Addendum No. 1 to IFB 19-74

To: All Parties on Record with the City of Somerville as Holding **IFB 19-74 Washington Street Water Main Upgrades**

CITY OF SOMERVILLE, MASSACHUSETTS WASHINGTON STREET WATER MAIN UPGRADES

1. **SHEET C-4– Water Main Plan – Washington Street STA 329+25 to STA 330+31**

C-4– Water Main Plan – Washington Street STA 329+25 to STA 330+31
MWRA Blowoff Revision.

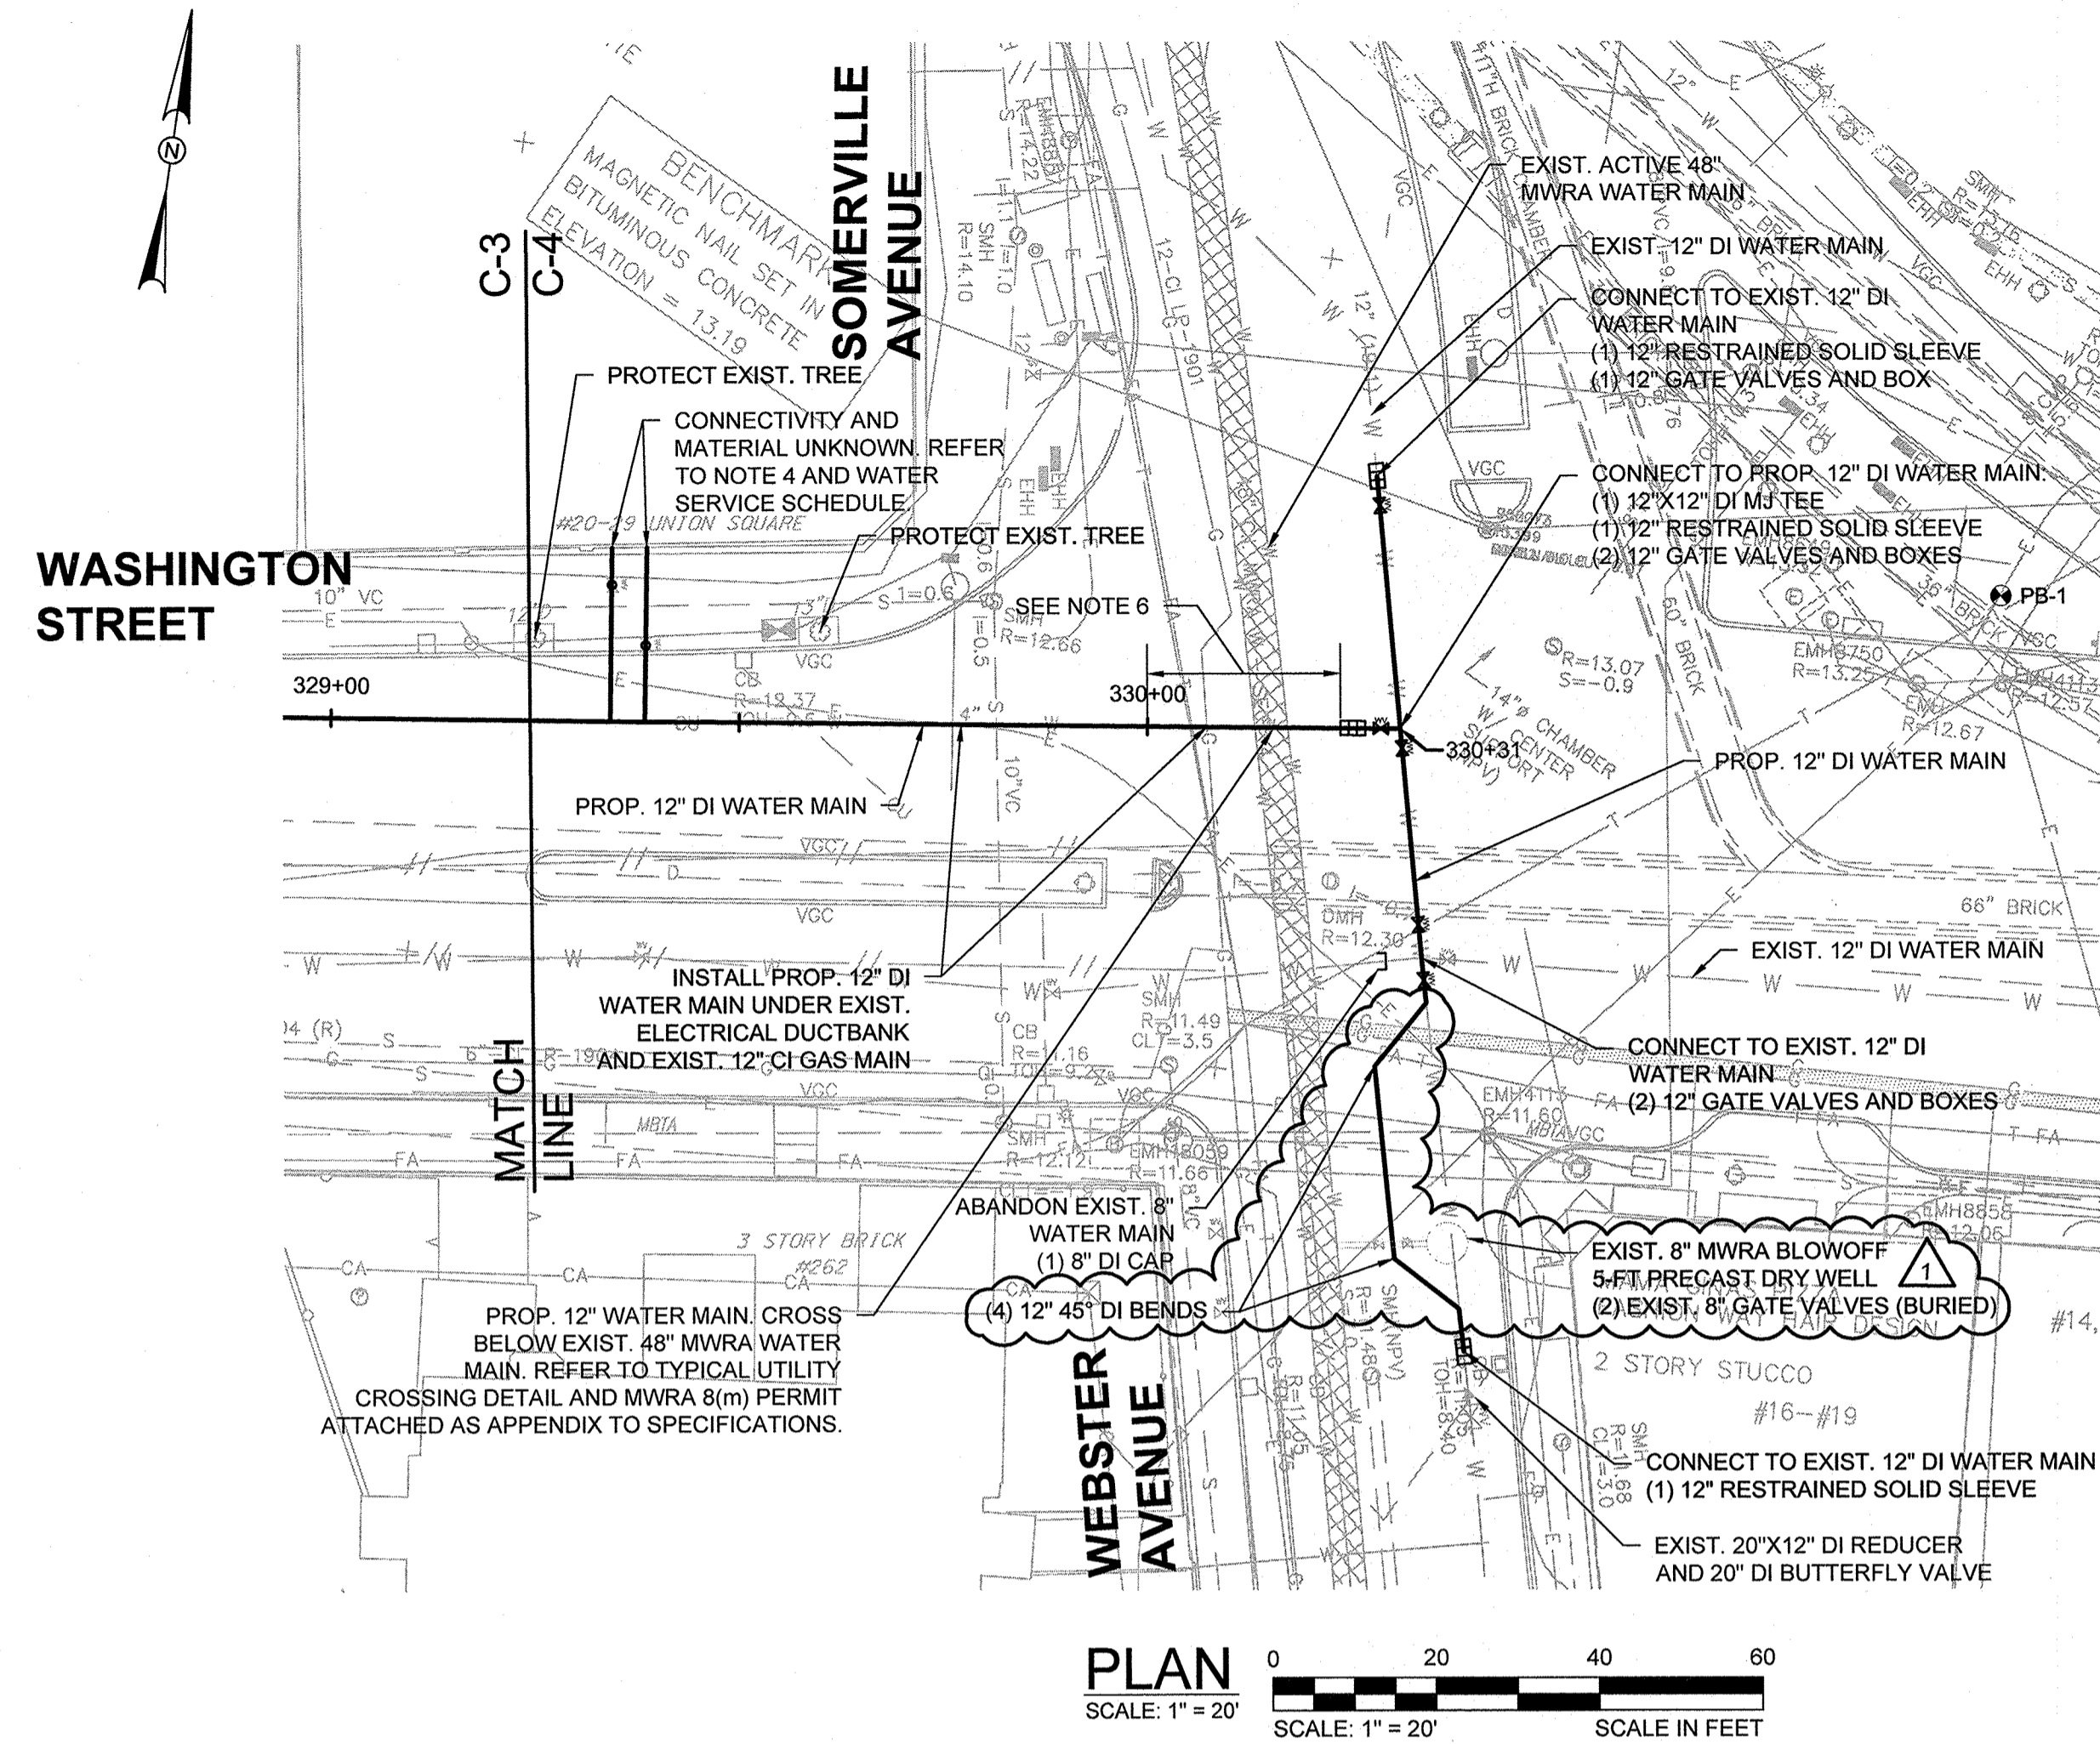
DELETE Sheet C-4 and **REPLACE** in its entirety Attachment 1, Sheet C-4, MWRA Blowoff Revision.

6. PROVIDE 12" DI WATER MAIN AND FITTINGS WITH VITON GASKETS FOR ALL JOINTS BETWEEN STA. 330+00 TO STA. 330+31
7. FOR ANY TEST PITS PERFORMED TO IDENTIFY EXISTING UTILITIES, CONTRACTOR SHALL TEST PIT VIA VACUUM EXCAVATION METHOD. FOR TEST PITS INTENDED TO IDENTIFY EXISTING WATER SERVICE MATERIAL, VACUUM EXCAVATION IS NOT REQUIRED.
